# DEVELOPMENT REVIEW BOARD REPORT

**Mountain View  
Shopping Center -  
Exterior Remodel  
22-DR-2023**

Request for approval of exterior building modifications to an existing shopping center, including the removal of the existing arcade and changes to roofing material and paint for a +/- 7.6-acre site.

issued for: DESIGN REVIEW

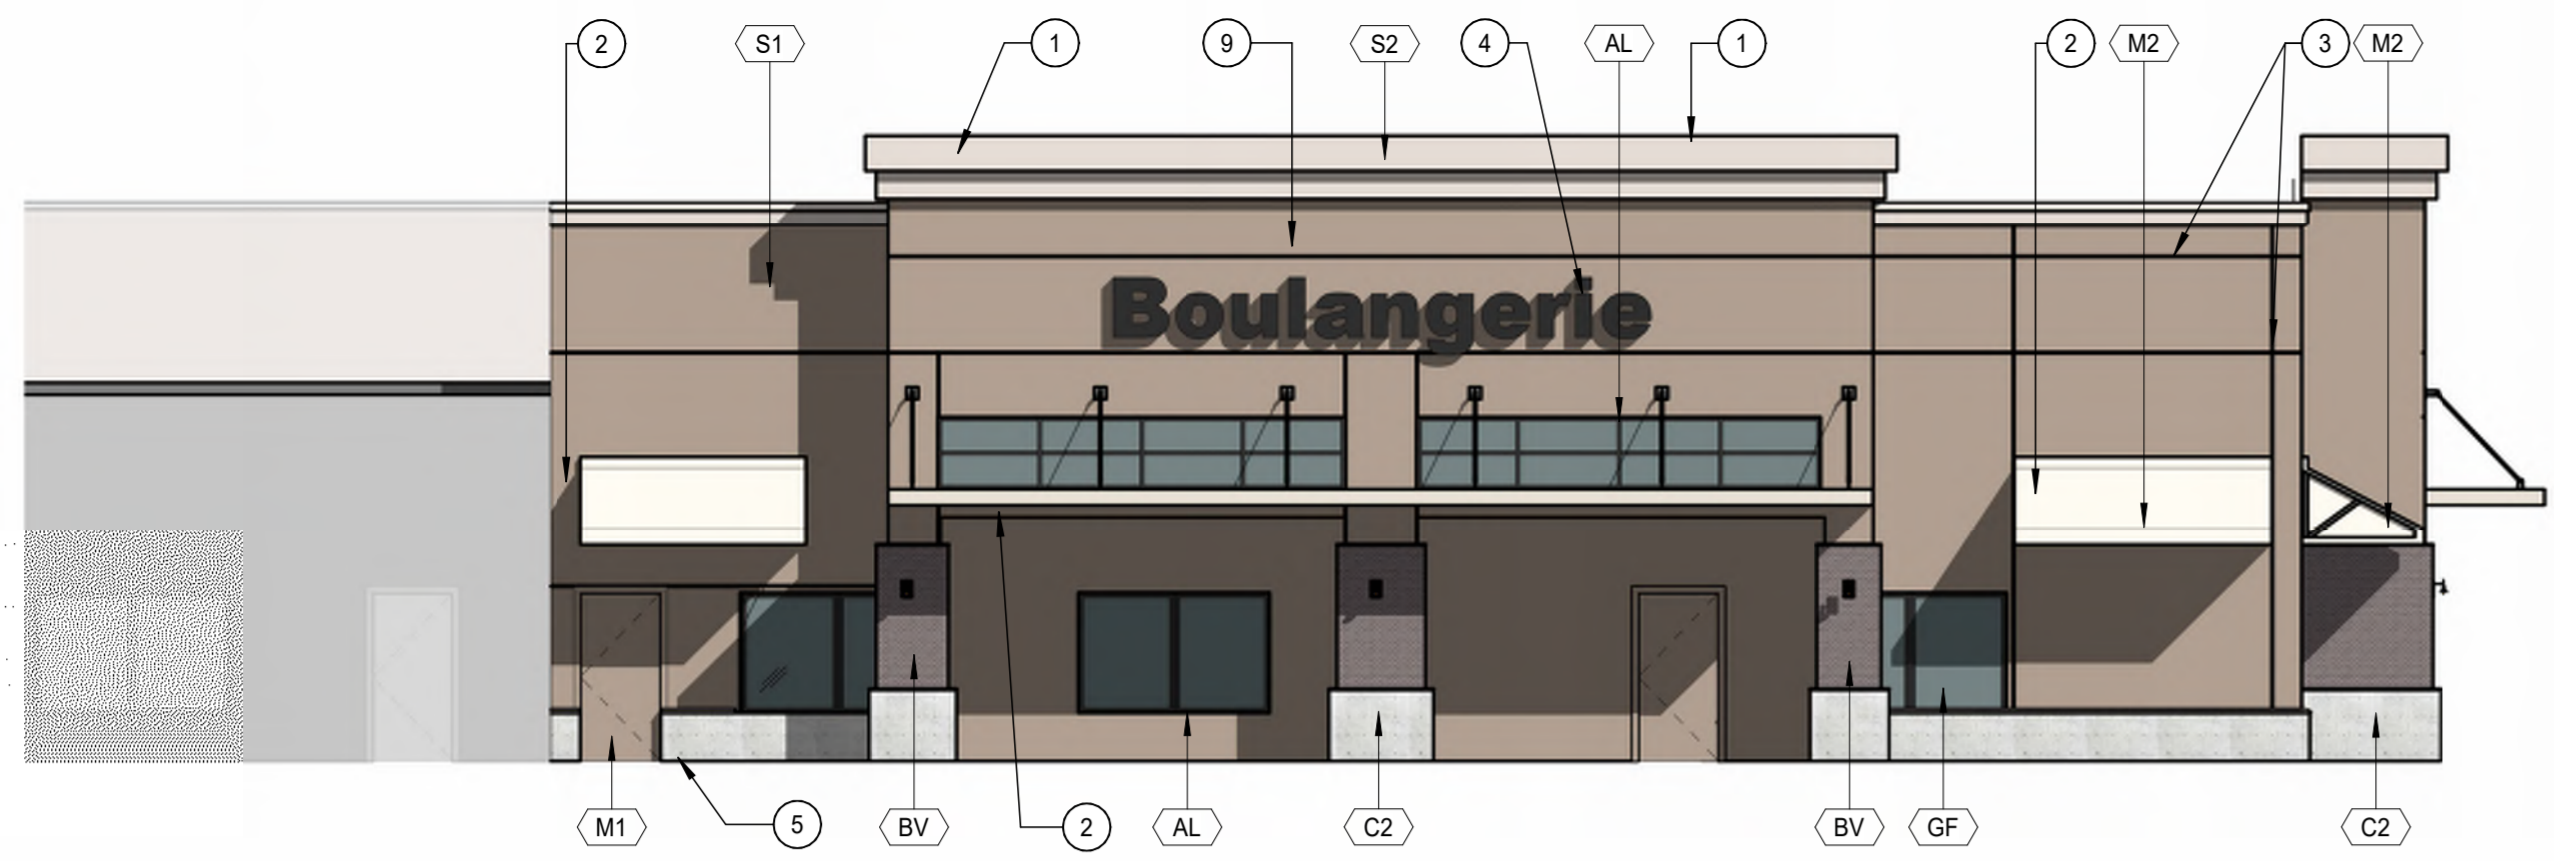
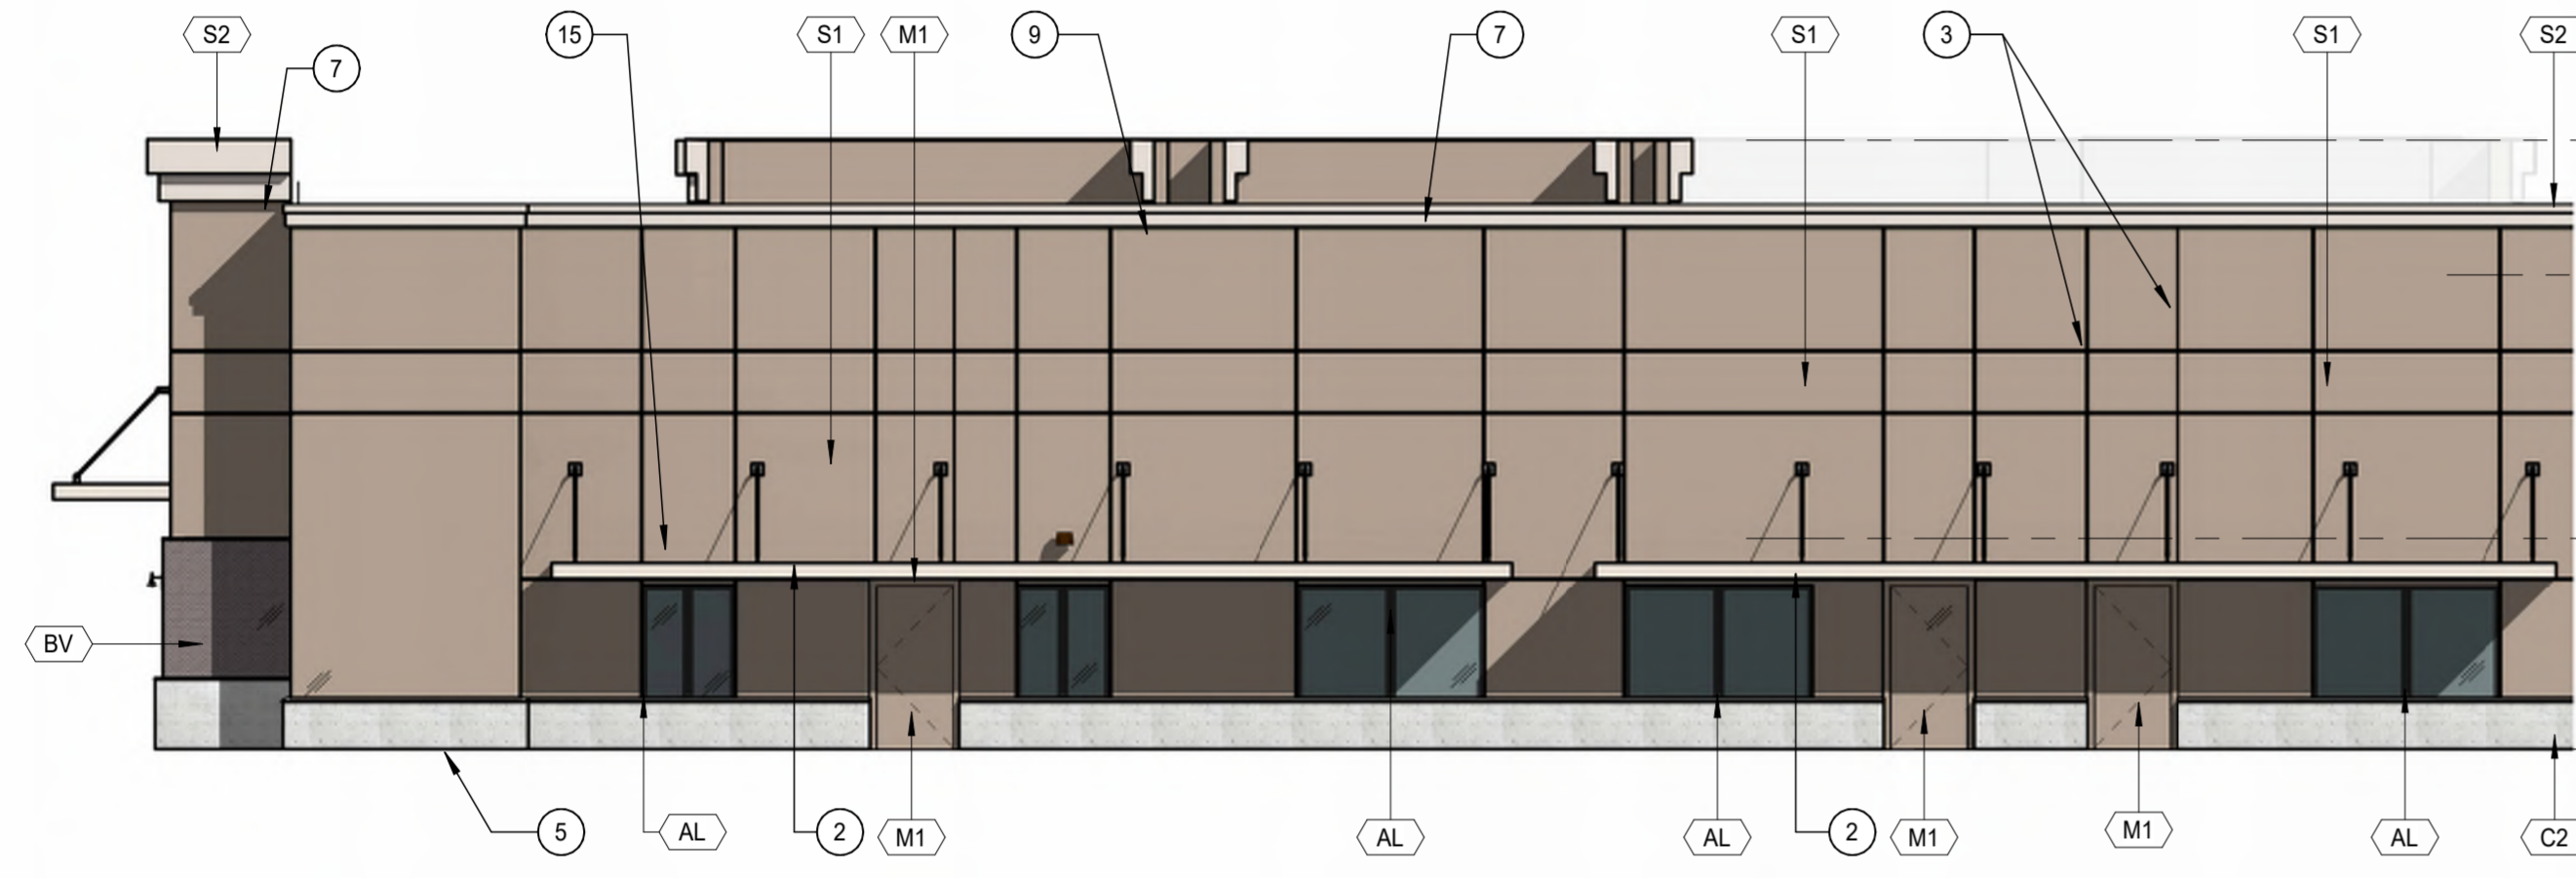
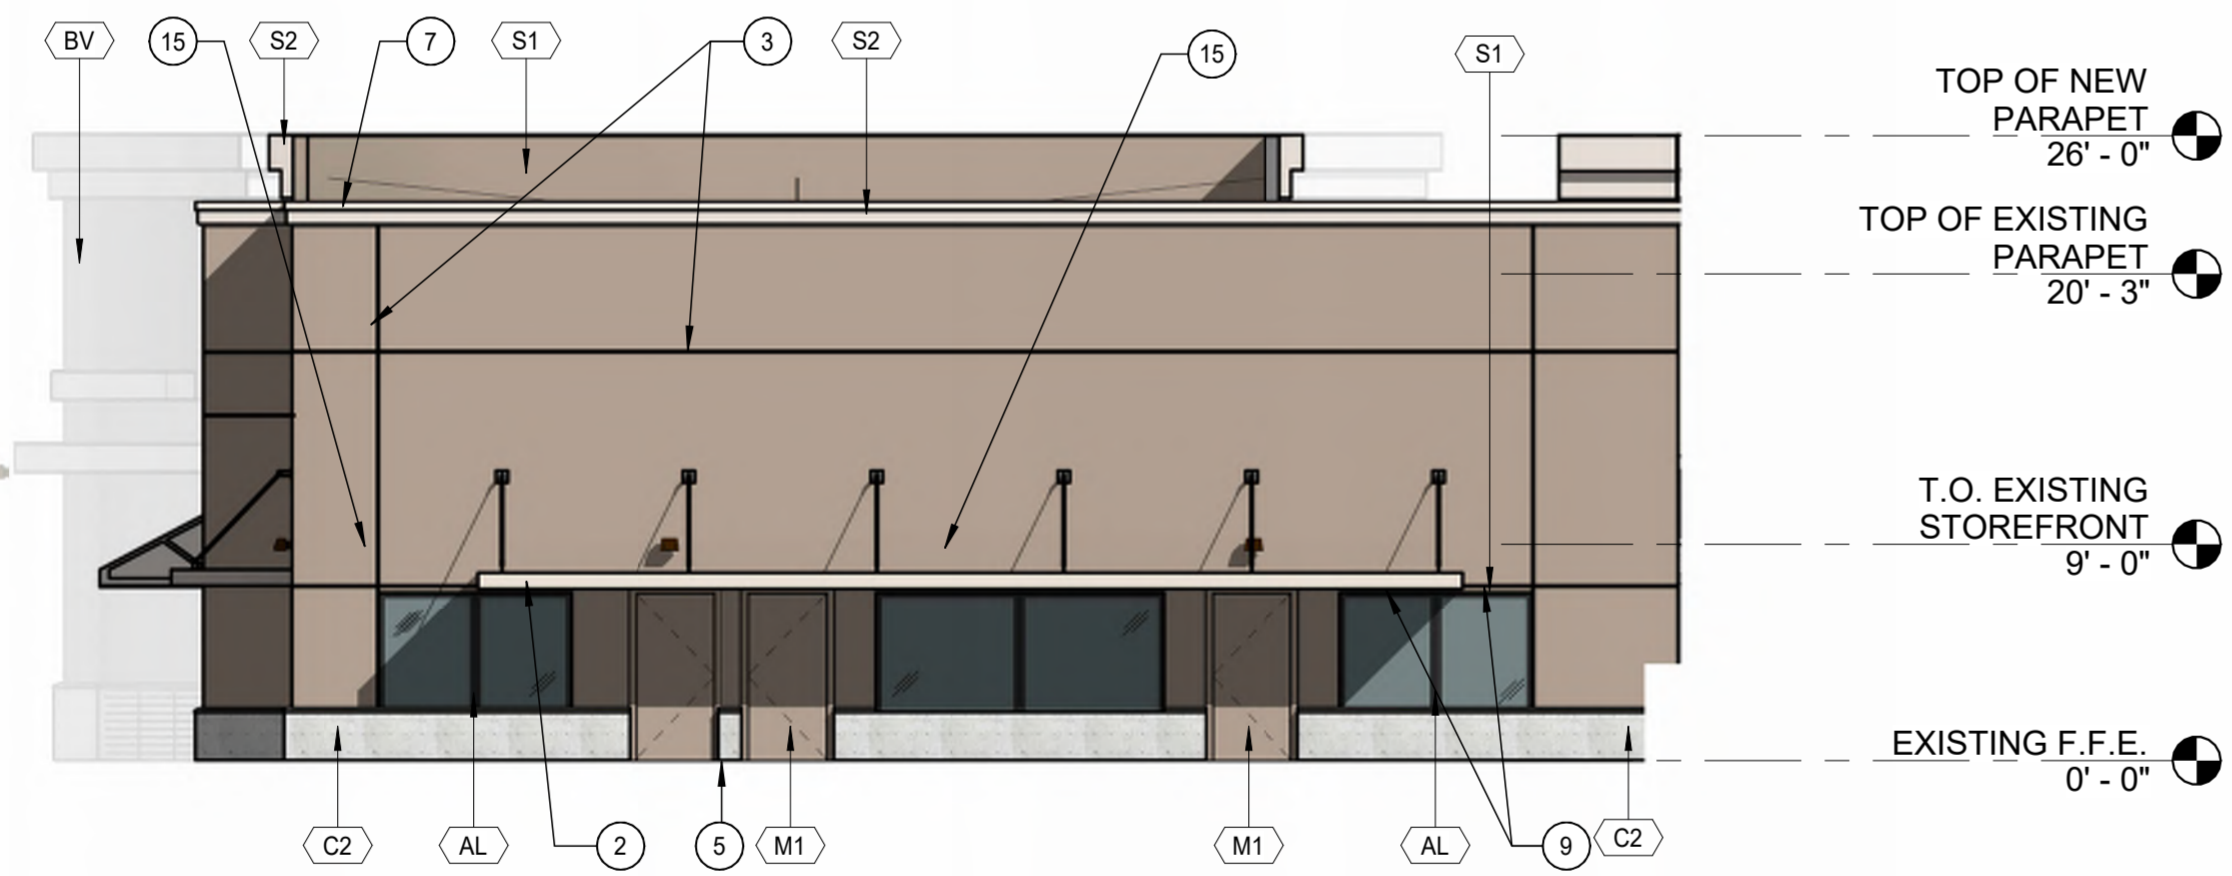
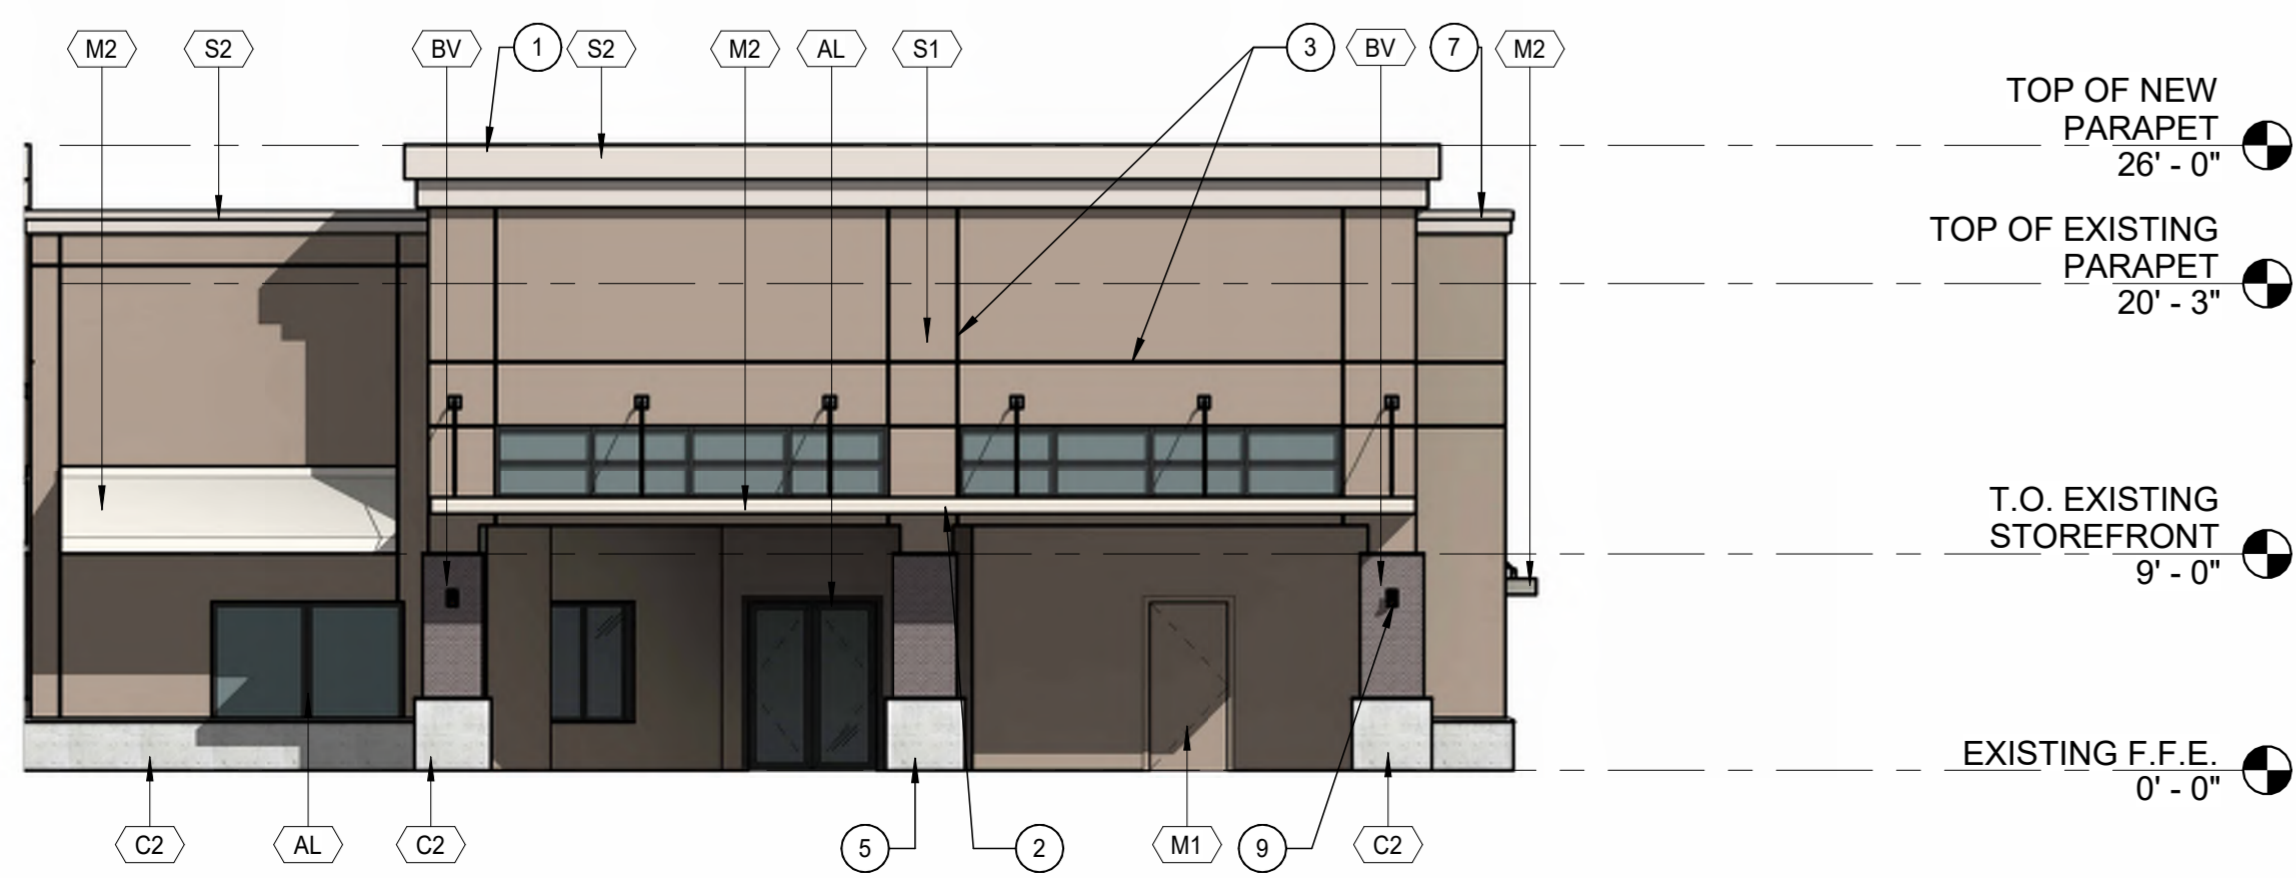
6. The concrete wainscot shall be extended to completely wrap all columns.
7. At time of final plans, the applicant shall submit updated elevations of all building facades to updated call out C2 as it does not exist. It should be C1.
